## **ARTICLE 14. ONE AND TWO FAMILY DWELLING CODE**

### **Rule 2.1. CABO One and Two Family Dwelling Code; Amendments**

FIGURE R502.8  
CUTTING, NOTCHING AND DRILLING

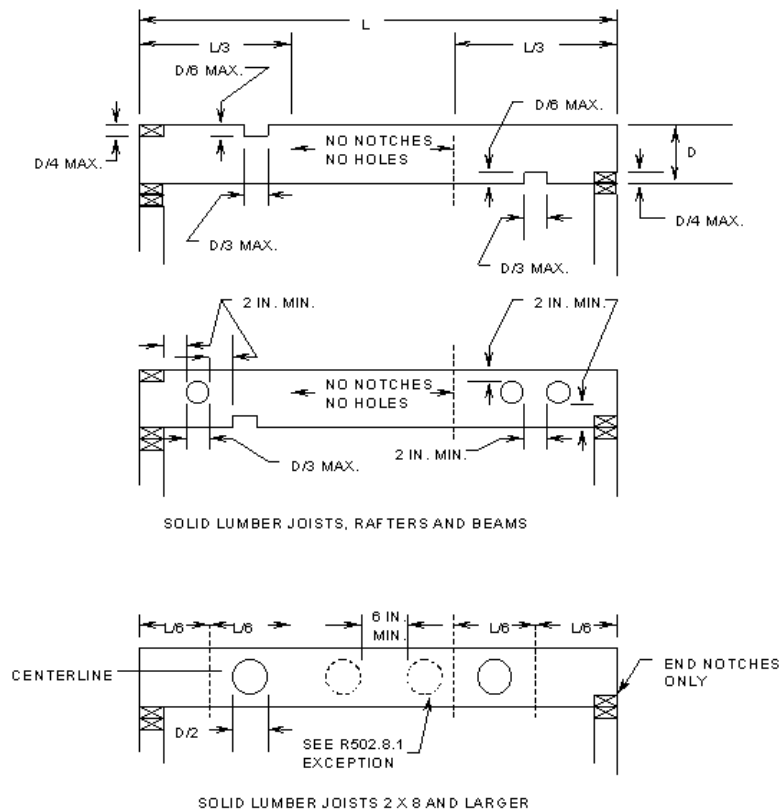
Sec. 88. Delete FIGURE R502.8 and substitute as follows: FIGURE R502.8:

FIGURE R602.6(2)  
NOTCHING AND BORED HOLE LIMITATIONS FOR INTERIOR NONBEARING WALLS

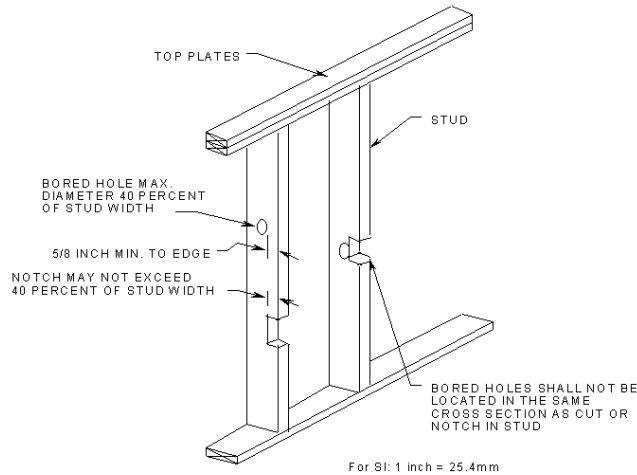
Sec. 95. Delete FIGURE R602.6(2) and insert FIGURE R602.6(2) to read as follows:

**FIGURE R602.10.5(2)**  
**GARAGE DOOR BRACED WALL PANEL FOR USE WITH CONTINUOUSLY SHEATHED WALLS**

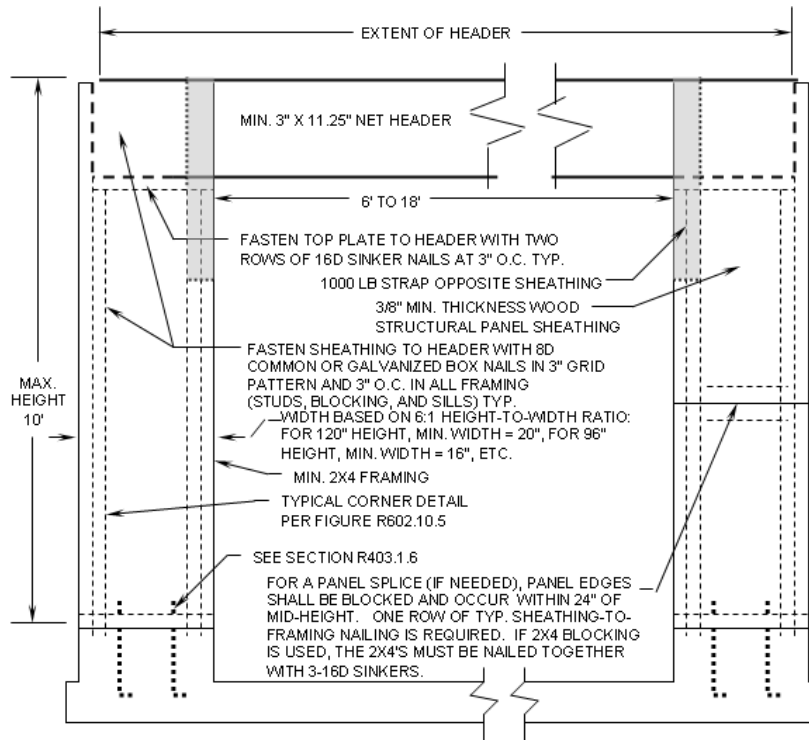
(4) Add FIGURE R602.10.5(2) to read as follows:

FIGURE R703.7.6(2)

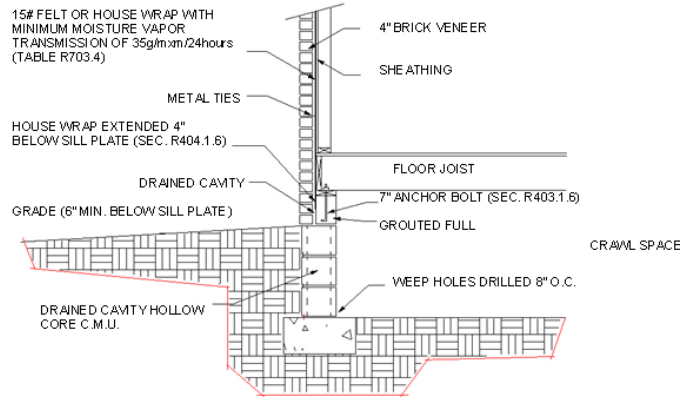
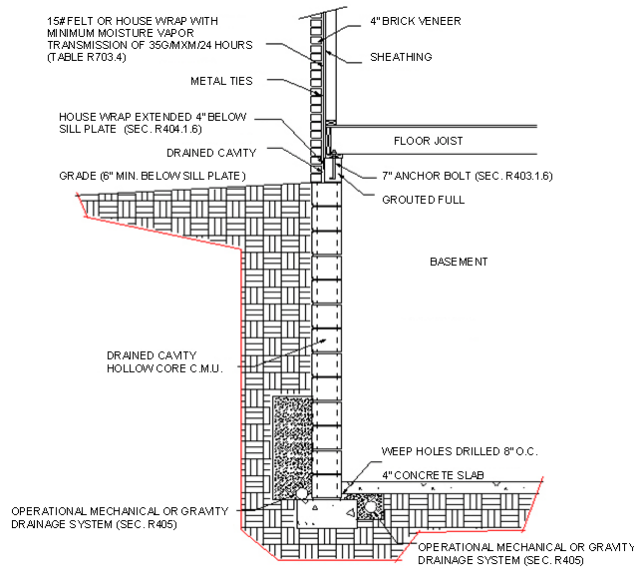
Sec. 121. Delete the title and text of SECTION R703.7.6 and substitute as follows: R703.7.6 Drained cavity. The  $\frac{3}{4}$  inch (19 mm) air cavity shall be drained to the exterior of the structure at intervals of not more than 33 inches (838 mm) on center. Each drain shall be not less than  $\frac{3}{16}$  inch (4.8 mm) in diameter, located immediately above the flashing. For dwellings with crawl spaces, the air cavity may be drained as shown in FIGURE R703.7.6(1). For dwellings with basements, the air cavity may be drained as shown in FIGURE R703.7.6(2).

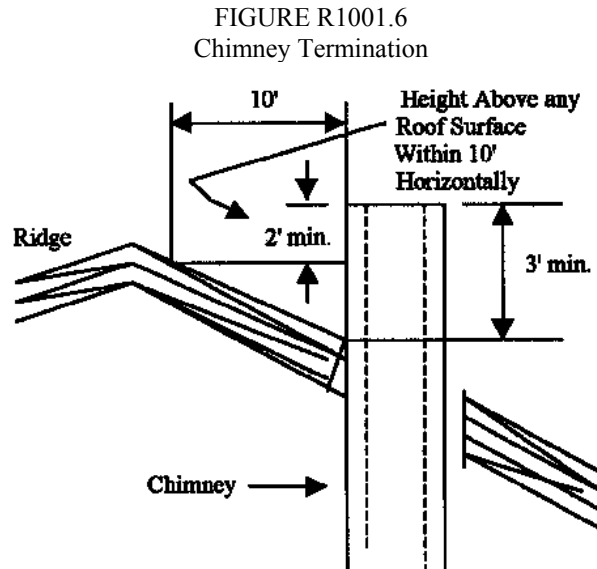
Sec. 135. Add FIGURE R1001.6 as follows:

**FIGURE E3801.4.1**

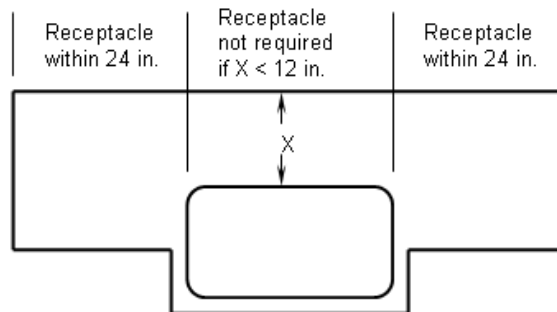
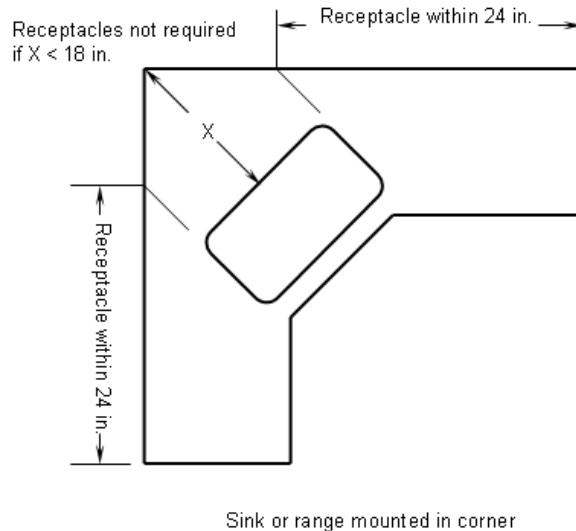
Sec. 229.5. (a) After SECTION E3801.4.1, add an exception to read as follows: Exception: Receptacle outlets shall not be required on a wall directly behind a range or sink in the installation described in FIGURE E3801.4.1.

(b) After SECTION E3801.4.1, add FIGURE E3801.4.1 as follows:
